Weber County – 12th Street Corridor, Segment 4

Owner : Weber County		Change Order #	4		
Engineer: Stanley Consultants					
Contractor: Staker Parson		Date:	12/26/2024		
Description: Change Precast Box Culvert to Cast In Place Box Culvert					
Item No.	Description	Unit	Quantity	Unit Price	Amount Increase/Decrease
82	Cast In Place Box Culvert Cost Difference	Lump	1	\$ 24,930.00	\$ 24,930.00
Total Net Changes for this change order					\$ 24,930.00
Original Contract Amount					\$14,663,836.25
Change Order 1 - Rock vs Sand					\$184,665.60
Change Order 2 - Additional Gravel for Drainage Pipe Foundation					\$29,120.00
Change Order 3 - Cathodic Protection					\$45,725.00
Change Amount of this Change Order					\$24,930.00
Total Adjusted Contract Amount					\$14,948,276.85

Weber County – 12th Street Corridor, Segment 4 Change Order 4

WEBER COUNTY 12TH STREET PHASE 4 BOX
CULVERT DESIGN
 7500 WEST 900 SOUTH
 HARRISVILLE, UTAH

STRUCTURAL
DETAILS
SD-1

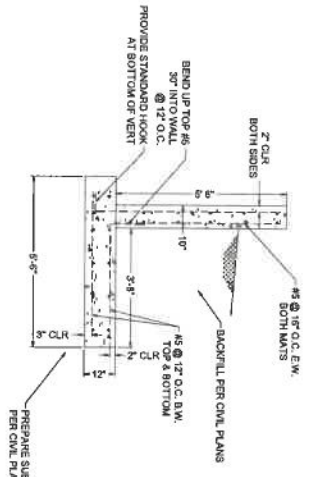
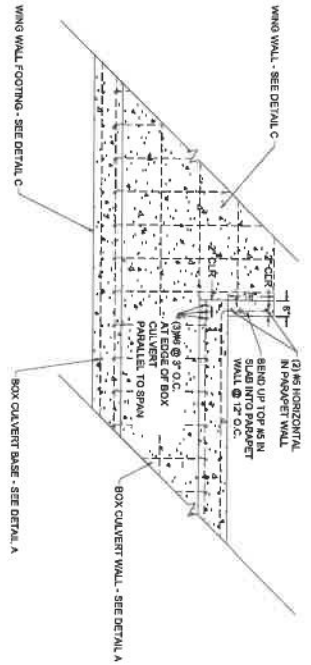
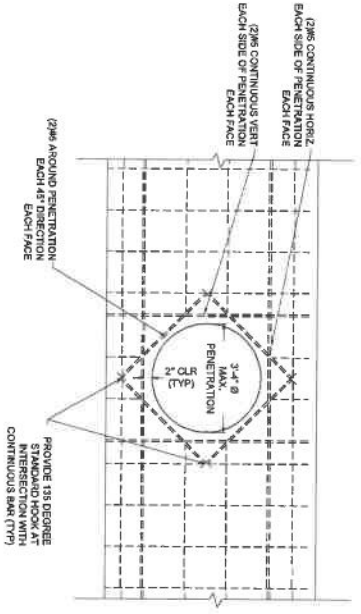
(82 – Cast In Place Box Culvert Cost Difference) To avoid major project delays it was agreed upon by the project team to change the precast box culvert on the irrigation canal to a cast in place box culvert. This pay item is to cover the difference in labor, materials and equipment necessary to install the cast in place box culvert in place of the precast box culvert. The contractor has submitted a lump sum price of \$24,930.00 to install the cast in place box instead of the precast box. The contractor's cost is shown in Exhibit B. An independent costs analysis was conducted by the engineer to verify the contractor's pricing. The engineer's costs analysis was conducted by comparing the full box culvert costs to costs from another current project on the same irrigation canal just a mile away. The engineer's cost estimate analysis showed the submitted costs to extend this irrigation culvert using cast in place are less than the cost on the nearby cast in place culvert. The submitted costs come to a total of \$2,715.00 per foot while the UDOT project's costs are \$3,556.34 per foot. The engineer's cost analysis is shown in Exhibit C.
